GENERAL NUCLEAR SYSTEMS, INC.

November 3, 1993
RA-0738-93

Subject: Revision 6 of the General Nuclear Systems, Inc. Quality Assurance Plan

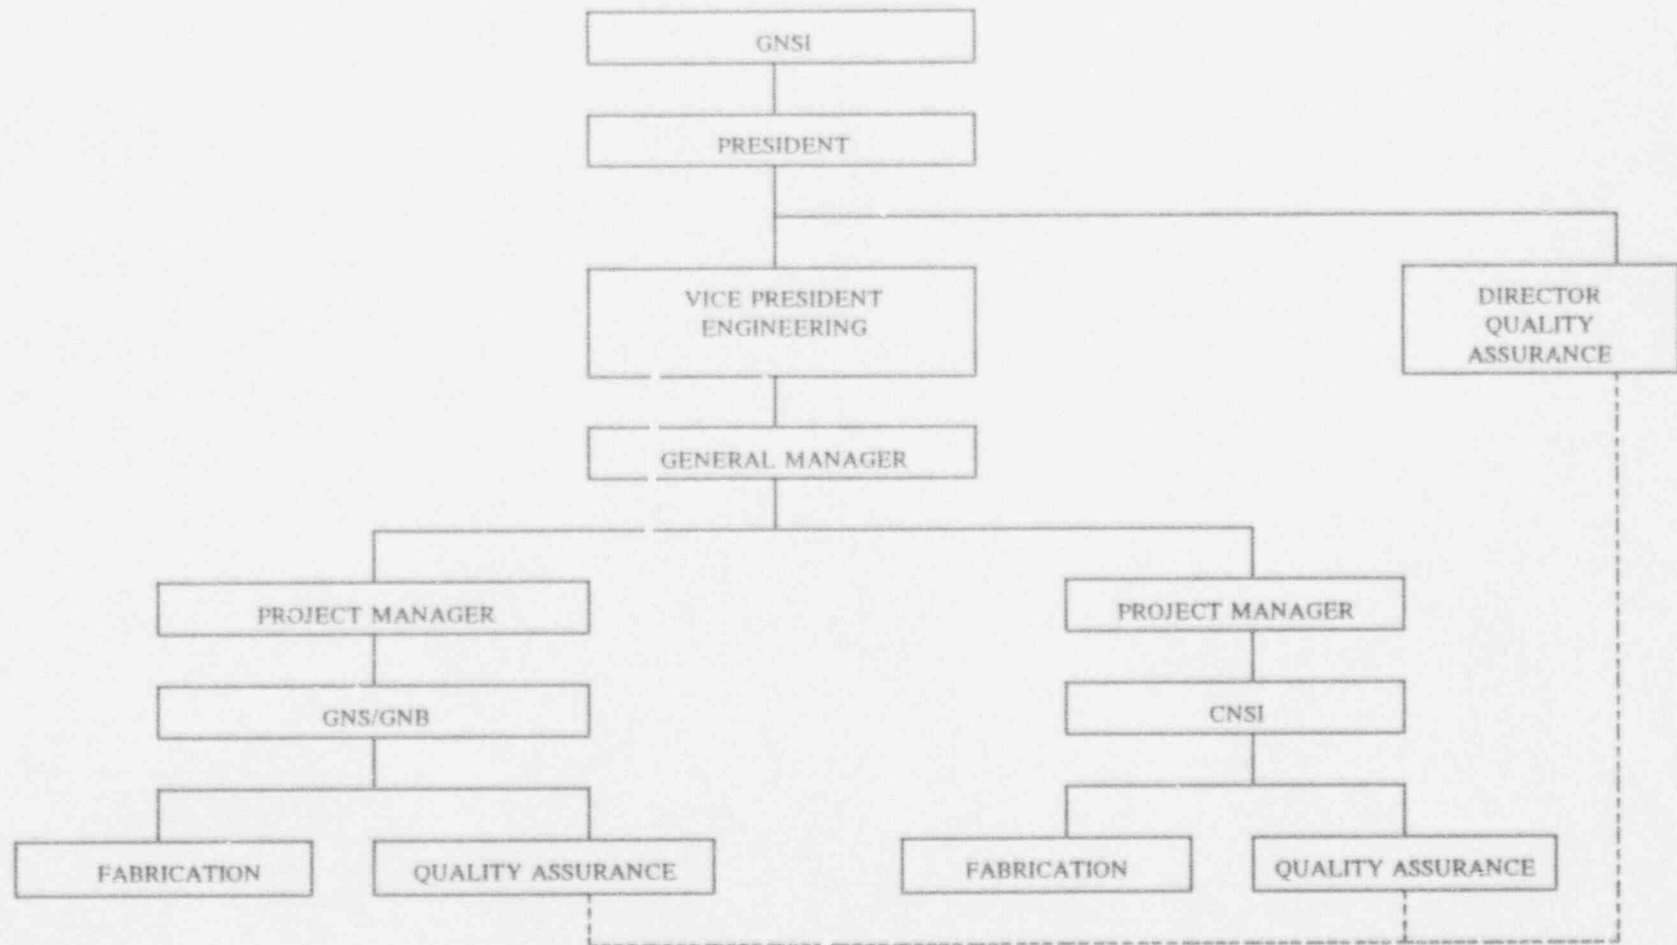
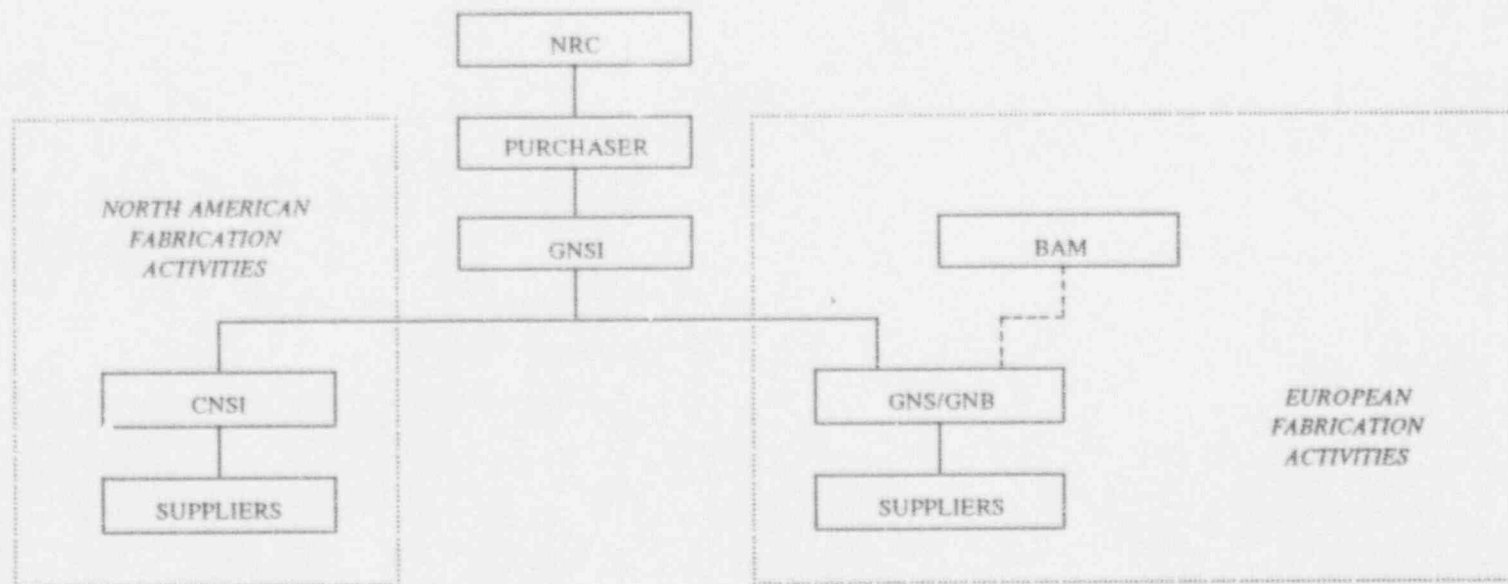
- In response to the general comments of the request for additional information, a specific statement that GNSI retains overall responsibility for the QA Program was added to section 1.3.1. This combined with the expanded introduction and the organization as depicted in Figures 1 and 2 of the GNSI QA Plan clearly show that GNSI retains overall responsibility for the QA Plan.
- The previous response to comment 6 stated that a graded approach discussion would be added to the GNS/GNB QA Plan. The graded approach is not currently being implemented by GNS/GNB. The graded approach may be incorporated in a later revision.
- An expanded discussion of Safety Review Board membership is included in the CNSI QA Program in response to comment 16.
